INTERNATIONAL PRELIMINARY EXAMINATION REPORT

PCT/EP 03/08066

EXAMINATION REPORT - SEPARATE SHEET

1/4

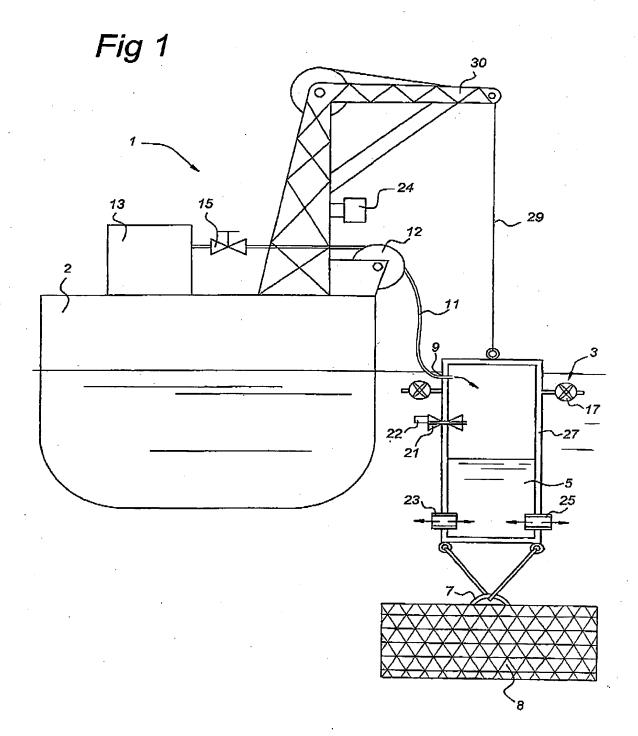
In the application as filed, such an attachment in a "non-rigid manner" was not explicitly disclosed. In the drawings and in claim 6 as filed it is disclosed that "the chamber is suspended from the floating structure via a guide cable". It is indeed true that there is an attachment in a "non-rigid manner" but this wording is a generalisation of what has been disclosed in the application as filed. Indeed an attachment in a "nonrigid manner" could be different than an attachment via a guide cable. Therefore is this amendment not allowable.

In claim 1 as filed "an equalisation opening" was disclosed, in the description as filed (for example on page 4, line 25) "equalisation openings 23, 25" were disclosed and in the drawings two equalisation openings (23, 25) are described. Therefore in the application as filed one or two equalisation openings are disclosed. The wording "at least" implies that three or more equalisation openings could be present which was not disclosed in the application as filed. This amendment is therefore also an unallowable generalisation.
